File # 984 - 0007

Project Name Text Amendment – Conditional Use Definition

PRELIMINARY PLAN
PROJECT NARRATIVE FOR
SUN CREST VILLAS
(FORMALLY SUNSET VALLEY VILLAGE)

REVIEW SHEET SUMMARY

PRELIMINARY DEVELOPMENT PLAN

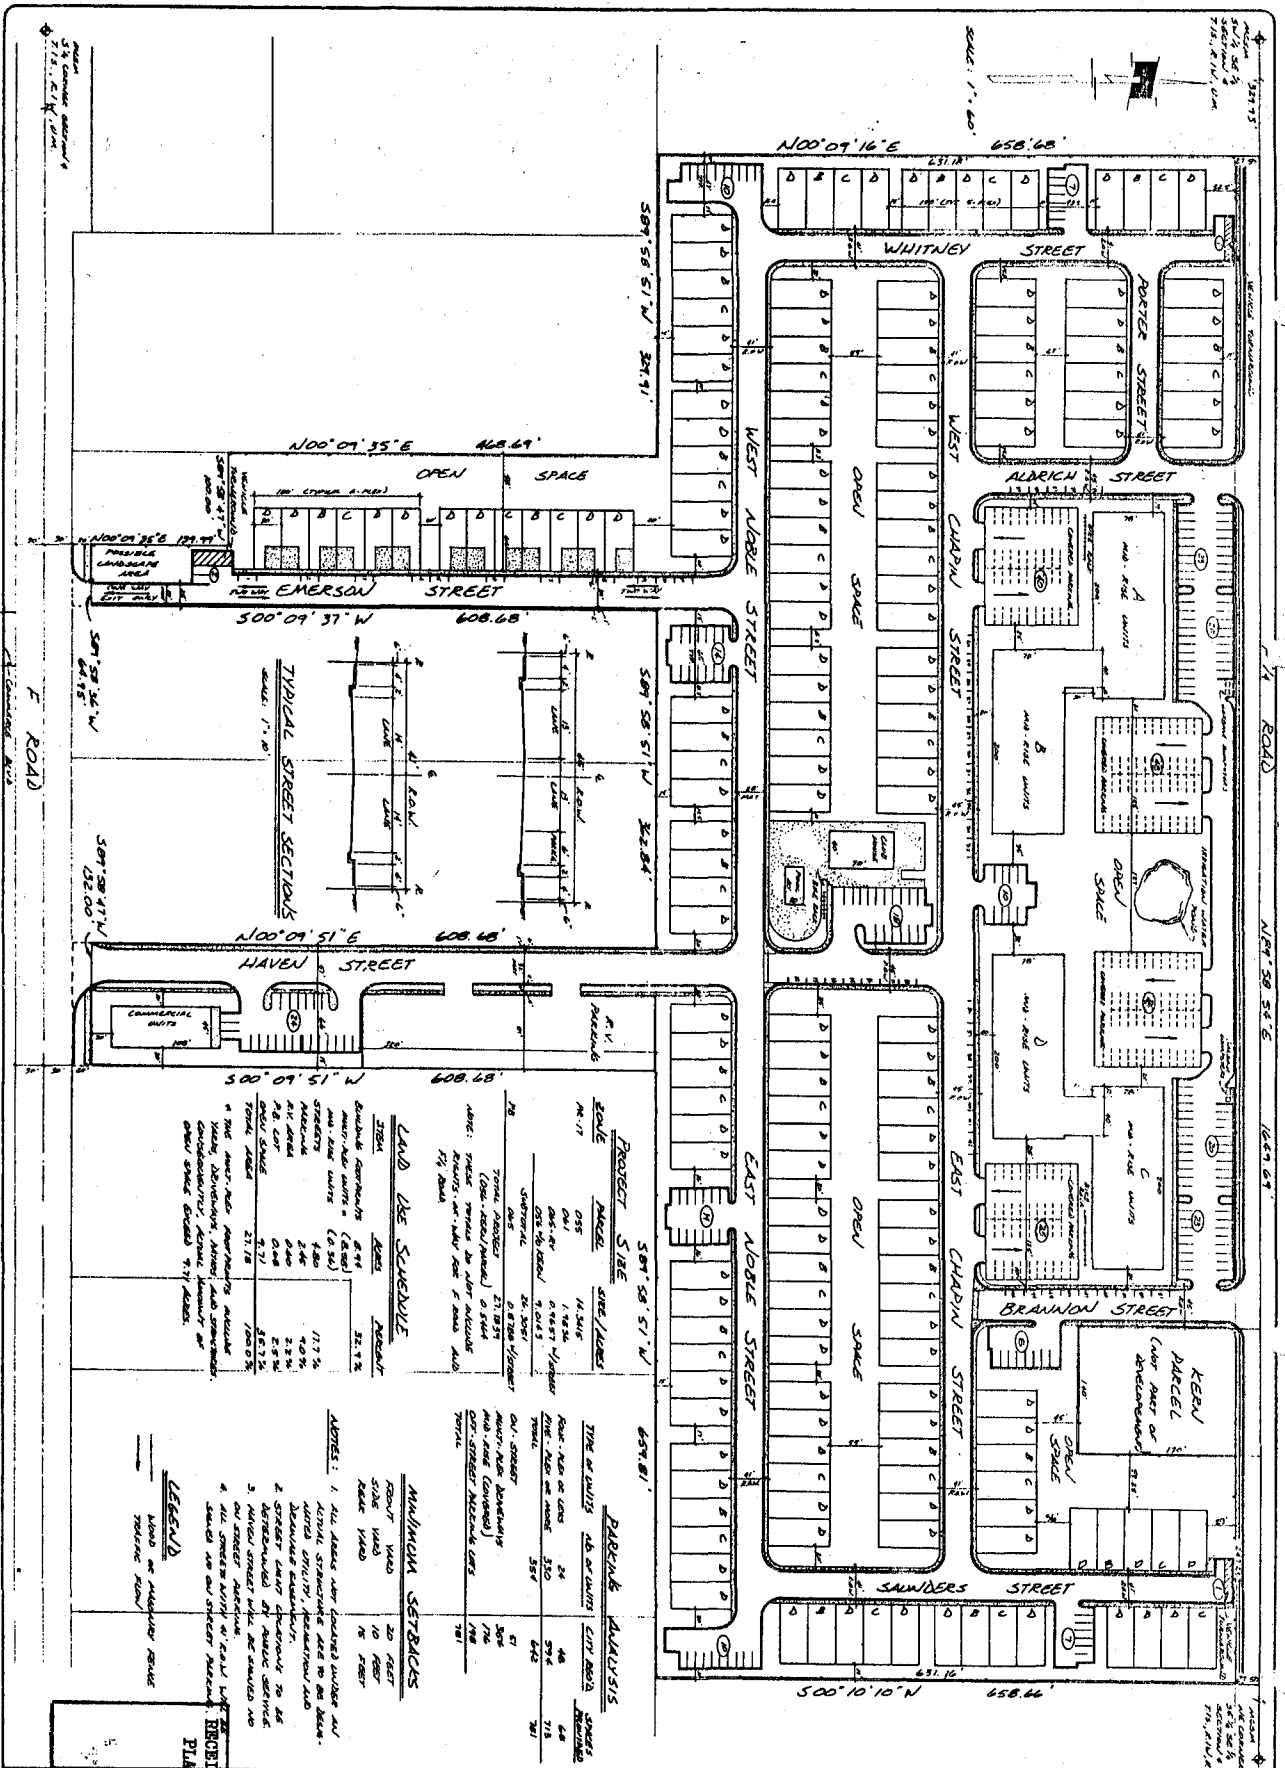
Petitioner's project narrative indicates that on-street parking will not only be prohibited but "is practically impossible due to the location of multiple driveways." Close evaluation of the Preliminary Development Plan reveals that on Haven Parkway, Aldrich Street, and Brannon Street, no significant driveways exist and on Chapin, Saunders, Noble, and Whitney Streets, only driveways on one side are shown in many areas. Since no driveway locations are shown, the evaluation of "practically impossible" is not possible but with the proposed parking layout, it seems likely overflow parking on the streets will be a significant temptation.

The Petitioner has not contacted this office to resolve cross-section design alternatives. It is my opinion that a standard street width of 34' of asphalt, 2' curb and gutter and 4' sidewalks both sides are needed on the main circulation streets. In areas where the designer can show that on-street parking is not likely such as Noble Street and Porter Street, a 28' mat with attached walk and curb and gutter section could be approved if the plans indicate a logical circulation pattern.

A hydrology report was requested in the ODP review of this project. The Grading and Drainage Plan does address some of the information requested but does not give detailed information about off-site incoming water, detention area storage capacities, methods of calculation, etc. Please have Petitioner complete a detailed hydrology report addressing location of inflow and discharge of drainage, calculations of composite runoff coefficient, design of detention inlets, volume of discharge from each detention basin proposed, and the location of each point of discharge as well as the ownership of the downstream receiving waterway.

Project Narrative: Could you clarify the original request for 17 units per acre when in fact you are now proposing only 13.5 units. (This is just for the records?) In part B, the discussion regarding private drive widths are in conflict with the City Engineer, Transportation Engineer and City Public Works requests or requirements for public drives. The motion of the Grand Junction Planning Commission was to coordinate with the City Engineer to satisfy the intents of Petitioner and the City. The plan itself shows 11' and 24' minimum stds. in conflict with the typical 13' driving lanes (not including curb) as discussed on page 5 of the narrative. The Petitioner must work with the City Engineer to resolve these conflicts prior to approval of this plan. The traffic analysis is acceptable for the use proposed and should not overburden F Road.

City Traffic Engineer - Based on a meeting with the City Staff on May 21, 1984, it appears that the City will accept the streets. A new preliminary plan has been prepared which reflects a series of changes to the streets. The changes correspond to the staff recommendations.

The only area that still may be in question concerns Whitney and Saunders Streets which still dead end. These areas have been redesigned whereby a vehicle can easily turn around if necessary. The turnaround areas will be properly signed indicating "no parking" allowed. The key design objective for the dead end areas is to discourage thru-traffic through the single-story, multi-plex homes. Pedestrian safety is of a major concern to the Developers. In addition, the Petitioner believes that two curb-cuts on F 1/4 Road is sufficient and the cuts are properly located.

The rectangular area at F Road and Emerson will most likely be used as a landscaping area. The detail for this area will be shown on the Phase I - Final Plan.

As recommended by the City Traffic Engineer, the location of crosswalks has been eliminated from the Preliminary Plan. The location of crosswalks will be determined by the City of Grand Junction.
